18 Grafton St.
Cherry Chase Village HD

MEMORANDUM

SUBJECT: Historic Area Work Permit #613583—additions and alterations to house and garage

MONTGOMERY COUNTY HISTORIC PRESERVATION COMMISSION
STAFF REPORT

PROPOSED FRONT ELEVATION

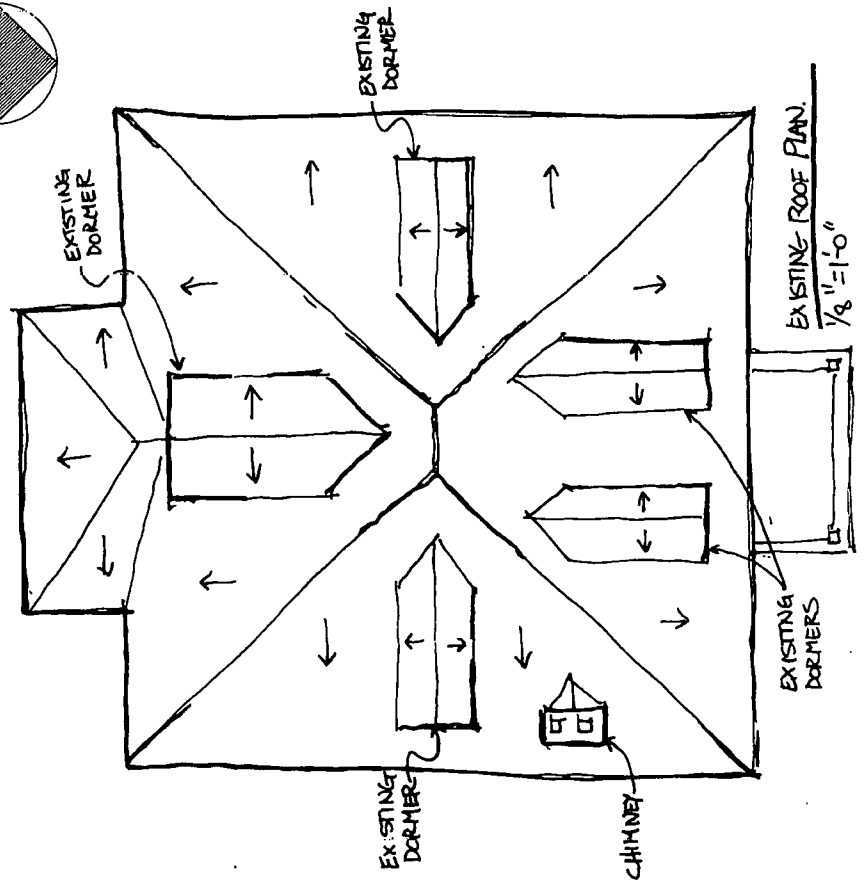
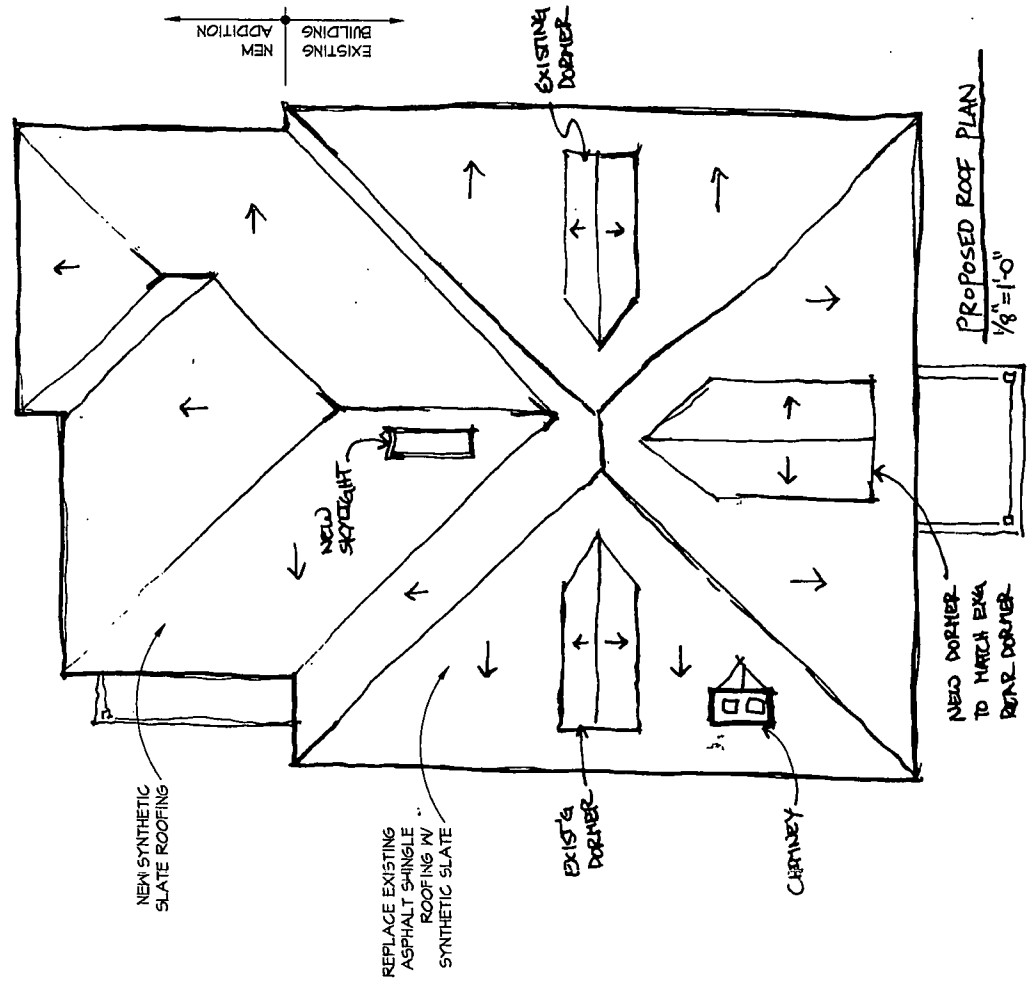
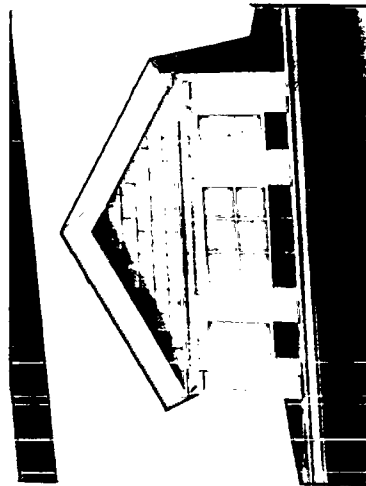
1. The front dormer will be reduced in scale to be proportionate to other similar front dormers in the neighborhood; final details will be reviewed and approved at the staff level.
